## Florida Department of Transportation

### **STRUCTURES DESIGN BULLETIN 20-06**

SUBJECT: Multirotational (MR) Bearings

**Figure 13.7-4 Anchor Rod Blockout for Composite Neoprene Bearings**

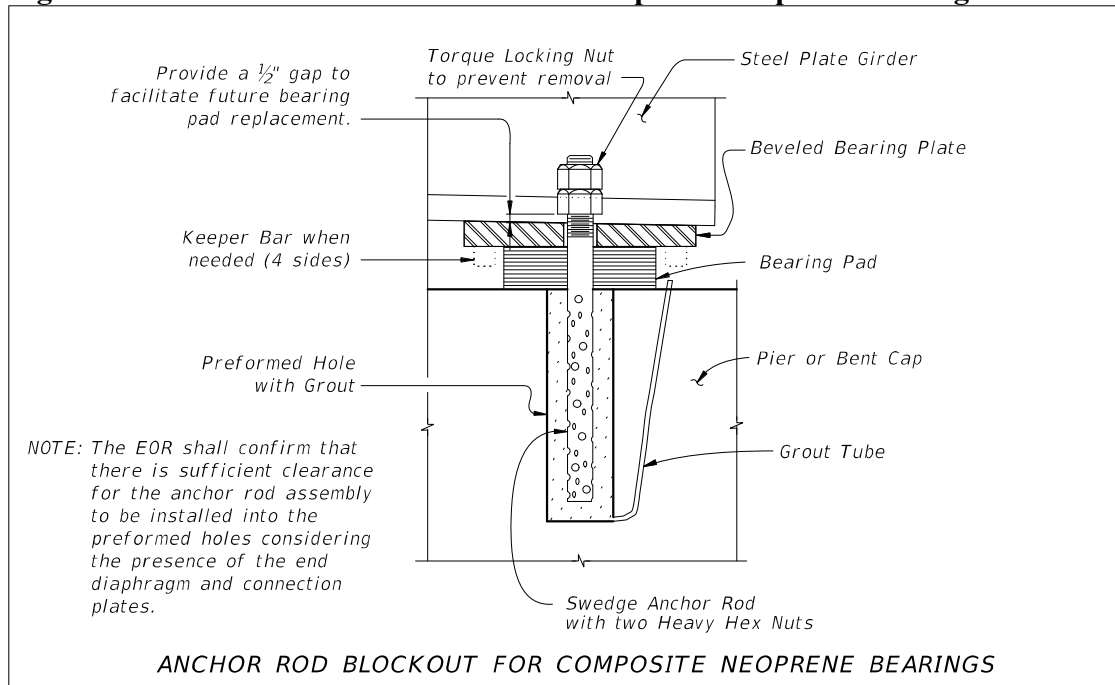
6. Replace **SDM** Figure 13.7-4 with the following:

- O. Preformed anchor rod blockouts shall be 4-inch diameter minimum. A larger size may be required to provide sufficient clearance for larger anchor rods, threaded couplers or grout/vent tubes. Completely detail blockouts and verify that there are no conflicts with reinforcement. Use either a corrugated galvanized metal form that is to be left in place or a smooth removable form. See Figure 13.7-4 and Figure 13.7-5 for anchor rod breakout details for composite neoprene and multirotational (MR) bearings, respectively.

**Figure 13.7-5 Anchor Rod Blockout for MR Bearings**

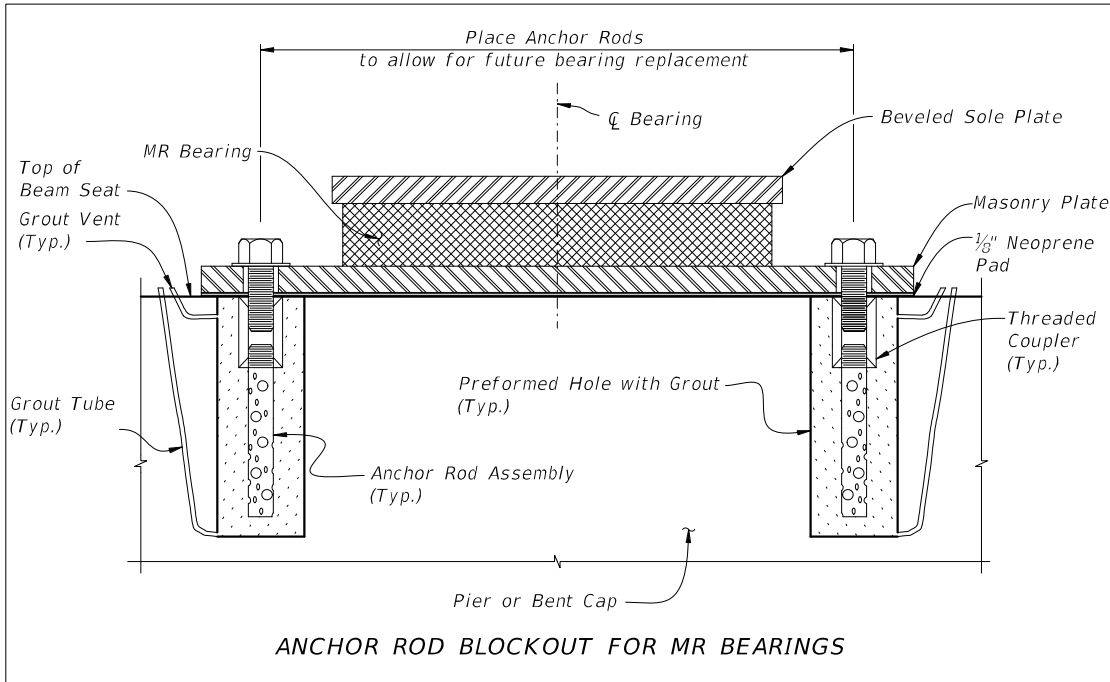
7. Replace *SDM* Figure 13.7-5 with the following:

**Figure 15.10.B-1 MR Bearing Type and Orientation Plan**

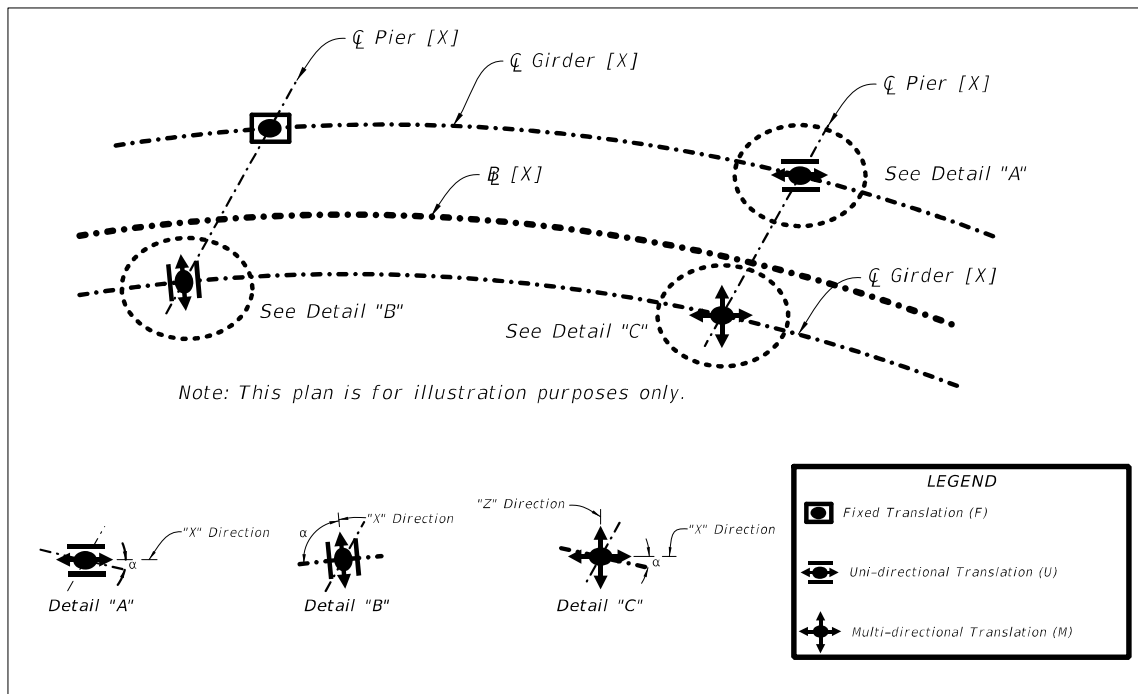
B. Provide a Plan view showing the MR bearing type and orientation. See Figure 15.10.B-1.

**Figure 15.10.D-1 MR Bearing with Steel I-Girder**

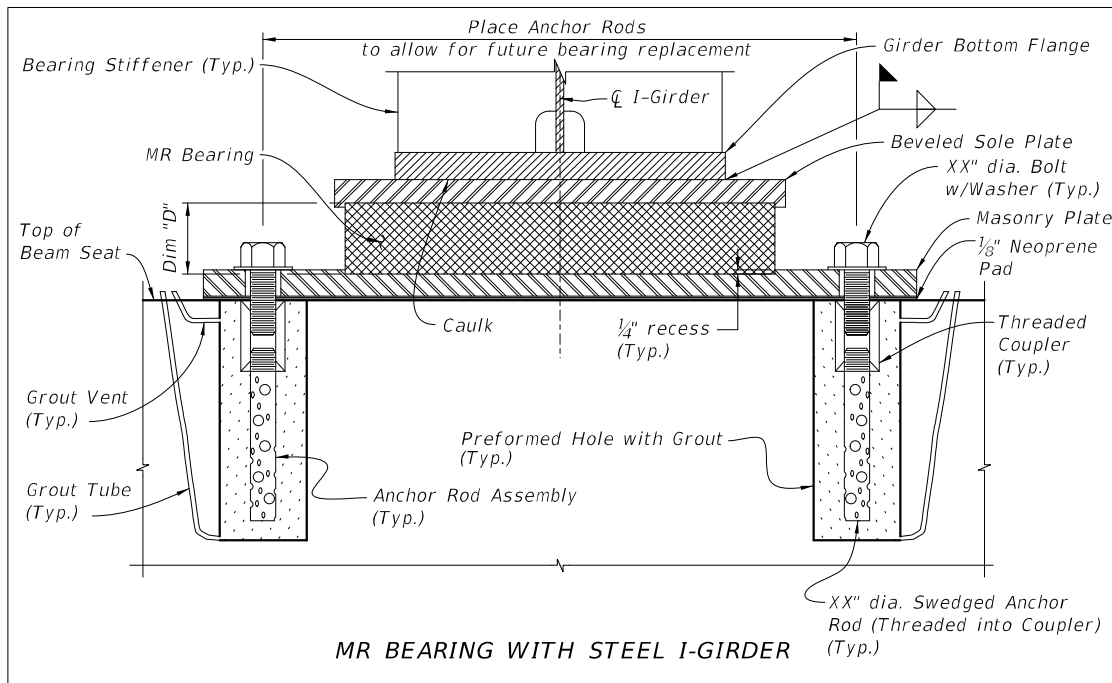
D. Provide a plan and elevation for each type of bearing assembly including the sole plate, masonry plate, connections to the MR bearing and anchor rod assembly. The MR bearing itself shall be shown only as an outline with hatching. See Figures 15.10.D-1 through Figure 15.10.D-3.
